**RE: Addendum No. 2
Canal Road Improvements from SR-161 to Wilson Blvd**

In response to questions and comments received by Thompson Engineering, Inc., and the City of Orange Beach, the plans, contract documents and specifications for the above referenced project are hereby revised as follows:

SHEET NO.: 45
 CANAL ROAD IMPROVEMENTS
 FROM SR-161 TO WILSON BOULEVARD
 SIGNING LAYOUT SHEET

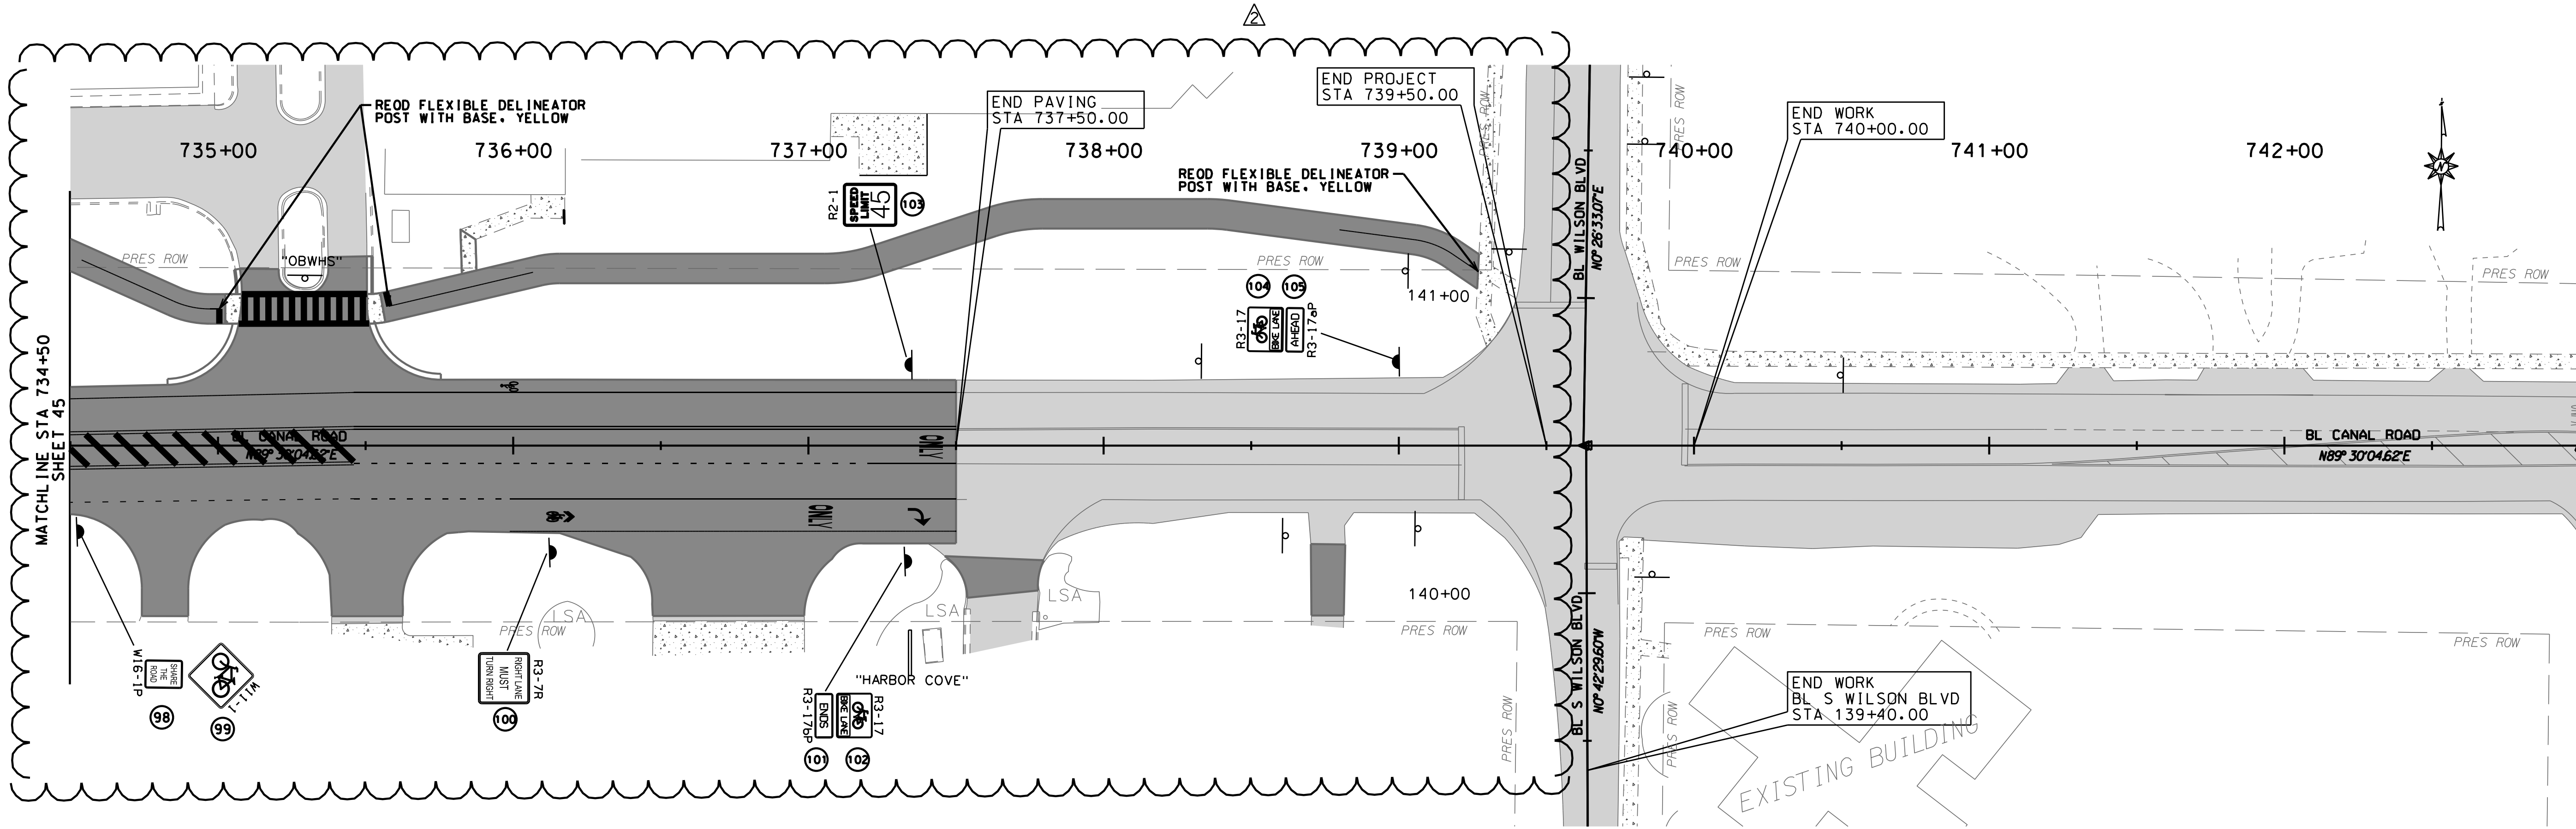
- VII. On Sheets 40 through 47, revise the signing plan as shown
 - VIII. Add the following sheets:
 - i. Sheets 2-K, 2-L, 2-M for additional typical sections
